**Proposed Rezoning From “AGR” & “GB” To “G/IC” for  
a Proposed “Social Welfare Facilities” (Residential Care Homes for The Elderly) (RCHE)  
Lot 232 RP, 232 S.A RP, 232 S.A ss. 1 to 14, 232 S.B RP, 232 S.B ss. 1 to 27,  
232 S.C to 232 S.E, 233 RP, 233 S.A to 233 S.M, 237 RP, 237 S.A to 237 S.R,  
239 RP, 239 S.A to 239 S.G in D.D.23, Tung Tsz, Tai Po, N.T.  
S12A Application for Planning Application No. Y/NE-TK/19  
Response-to-Comment – PlanD  
(Updated 19 February 2025)**

VIEWPOINT  
LOCATION PLAN

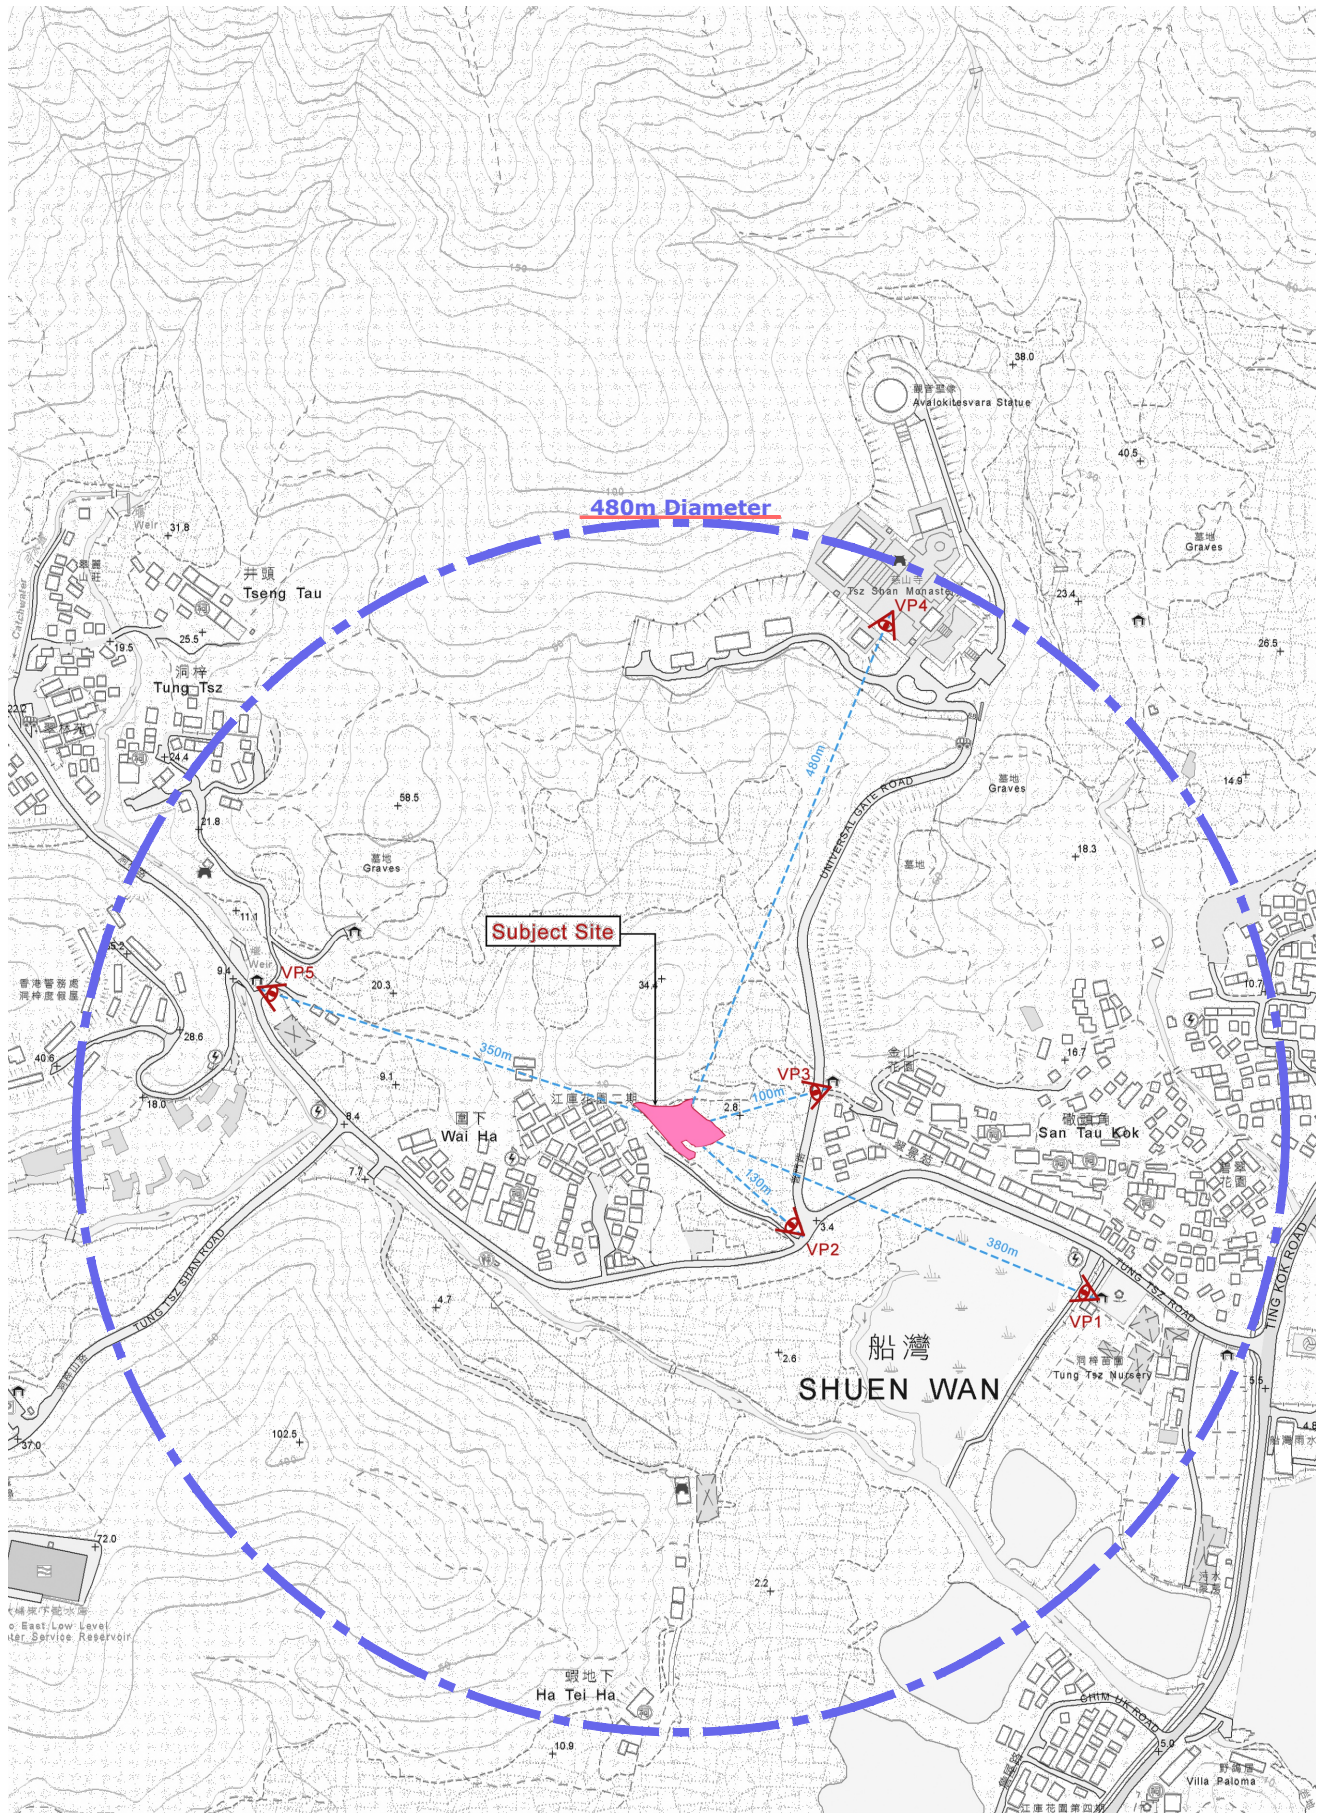
Comments	Response
11. All proposed visual mitigation measures should be provided in the VIA.	Vertical green wall would be proposed.
12. According to the TPB PG-No.41, “fully acceptable” is not one of the thresholds of the visual impact.	Noted.
13. Figure 3 Viewpoint Location Plan – The extent of the assessment area of the VIA is not shown in the plan.	Revised accordingly. Please refer to Figure 3.
